Re: Sketch Plat Submittal; Project #1010812; Lots 15A and 16A, Alvarado Gardens Unit 2

**Development Review Board (DRB)
Review Comments
Utility Development Section
Reviewer: Kristopher Cadena, P.E.
Phone: 505.289.3301**

**CITY OF ALBUQUERQUE
PLANNING DEPARTMENT
April 13, 2016
DRB Comments**

**Boundary Survey
and
ALTA/NSPS Land Title Survey
for
Lots 15-A and 16-A
Alvarado Gardens, Unit No. 2
City of Albuquerque
Bernalillo County, New Mexico
April 2016**

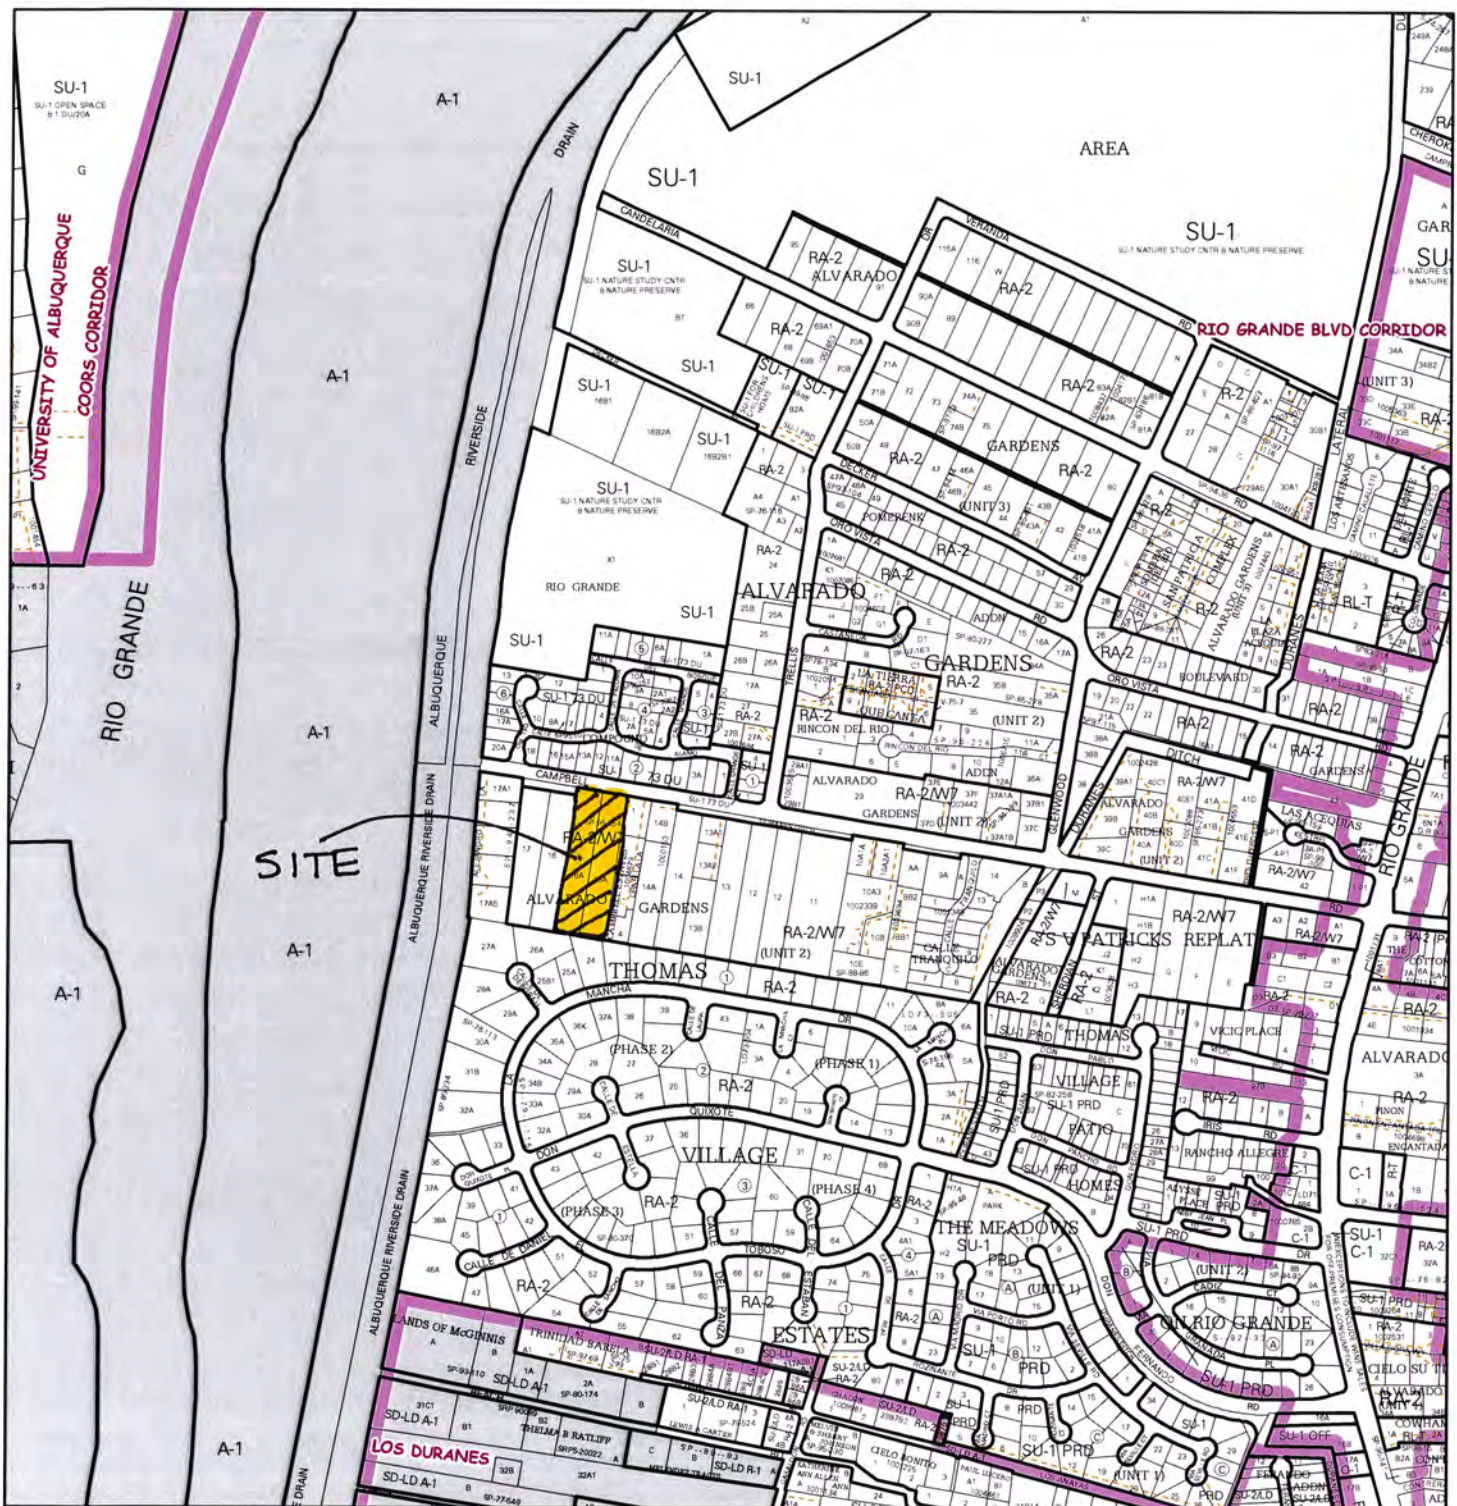
The layout features a 28-foot private roadway easement with a 48-foot radius cul-de-sac that is primarily a single loaded street. It is assumed that a sidewalk waiver will be requested for the west side of the street, as well as a request for a Subdivision Design Variance for the private roadway easement width. A sidewalk on the east side of the property will be provided within the 10-foot public utility easement.
